# UNITED STATES PATENT AND TRADEMARK OFFICE

APPLICATION NO.	FILING DATE	FIRST NAMED INVENTOR	ATTORNEY DOCKET NO.	CONFIRMATION NO.
10/611,694	07/02/2003	Cheng-Fong Chen	SP3019-P-1339-AAF	4432
7590 Cheng-Fong Chen 235 Chung - Ho Box 8-24 Taipei, TAIWAN			EXAMINER GANDHI, JAYPRAKASH N	
			ART UNIT 2125	PAPER NUMBER
DATE MAILED: 11/30/2004

## Office Action Summary

## DETAILED ACTION

U.S. Patent Jul. 31, 2001 Sheet 1 of 7 US 6,267,297 B1

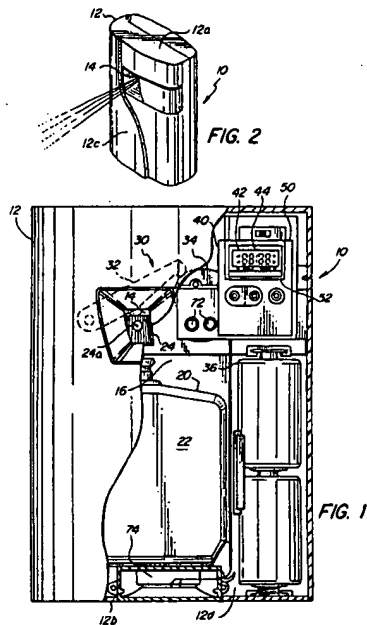
7. Claims 1-6 as best understood are rejected under 35 U.S.C. 102(b) as being anticipated by Contadini et al. (U. S. Patent 6,267,297).

Contadini discloses the claimed invention of a deodorizer control device (programmable dispenser) including a control device 40 with LCD, keyboard, power supply, different operation modes,

U.S. Patent Jul. 31, 2001 Sheet 4 of 7 US 6,267,297 B1

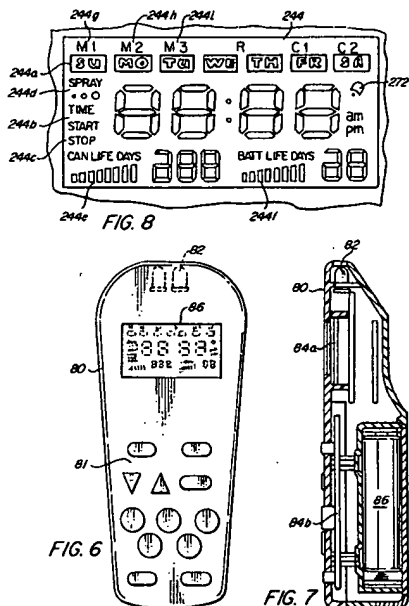
even though I/O port, CPU, are not shown but are inherent properties of control device of Contadini to operate.
